**R A D I O C A T**  
Centers For The Treatment Of Feline Hyperthyroidism

July 18, 2025

RE: RADIOCAT, LLC, LICENSE NUMBER 45-25330-01  
REQUEST FOR ADDITIONAL INFORMATION, MAIL CONTROL NO. 625737

Figure 2: A person carrying a cat carrier with dose points.

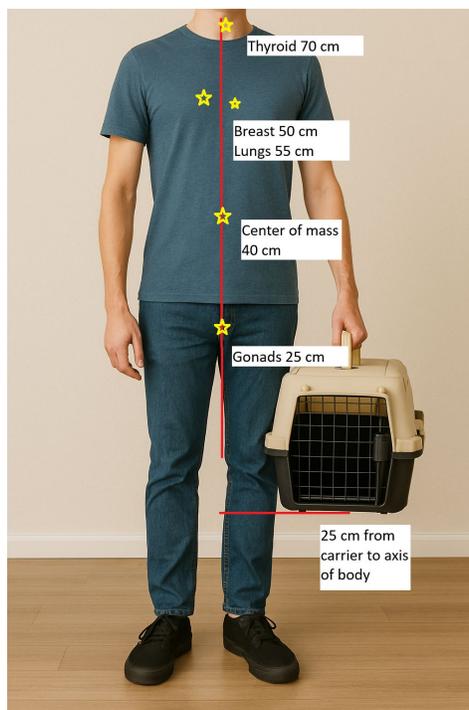
- (b.) Your revised procedures below are more conservative, but it assumes that the owner will be at least 1 foot away from the cat for the first four weeks following treatment. Since there will inevitably be incidental close contact (e.g., when the owner is transporting the cat home in its carrier, if the cat needs medication and

needs to be picked up to be pilled, the cat rubs up against the owner's legs during mealtime, etc.) where the owners could be in direct contact (less than 1 foot) from the cat for brief periods of time, please either demonstrate that these scenarios would not exceed the 2 mrem in any one hour dose limit, or include a time limit in your instructions for this incidental close contact.

To transport the cat from the clinic, a carrier would be used. This situation is depicted in Fig. 2. Considering the crate is held just above the knee at lower thigh level, the EDE rate in this configuration is 1.194 mrem/hr, below 2 mrem per hour. If it takes an owner a total of 1 minute to load the cat into the car, and another 5 minutes to bring the cat inside their residence, the total EDE is 0.119 mrem.

<b>Tissue</b>	<b><math>W_T</math></b>	<b>Distance (cm)</b>	<b>EDE Rate (mrem/hr)</b>
Gonads	0.25	35.4	0.444
Breast	0.15	55.9	0.106
Lung	0.12	60.4	0.074
Red Bone Marrow	0.12	47.2	0.120
Thyroid	0.03	74.3	0.120
Bone Surfaces	0.03	47.2	0.030
Remainder	0.30	47.2	0.300
<b>Total</b>	<b>1.00</b>	<b>-</b>	<b>1.194</b>
